CITY COUNCIL STAFF REPORT

SUBJECT: Discussion of the Proposed Creekside Memorial Park Cemetery in Tassajara Valley

Creekside Memorial Park Cemetery

San Ramon City Council Study Session
June 24, 2014

Upper Entombment Area

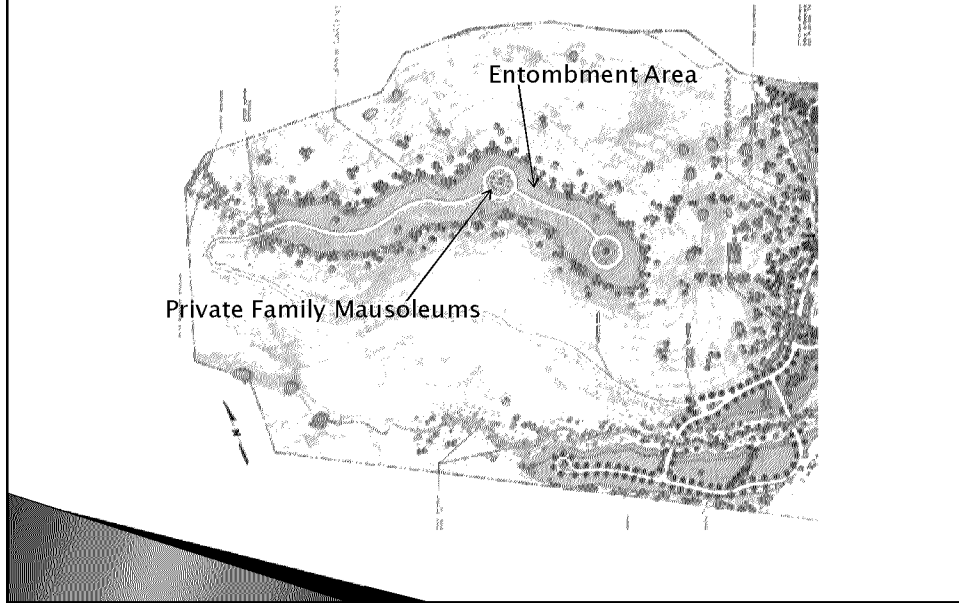
City of San Ramon's Comments on DEIR

- ▶ Tassajara Valley within our Planning Area,
- ▶ A vested interested as to what development occurs.
- ▶ Views of the cemetery from Tassajara Ridge
- ▶ Encouraged modifications
 - Eliminate the highest roundabout
 - Reduce entombment area to lower elevation

Eliminate Roundabout and entombment area
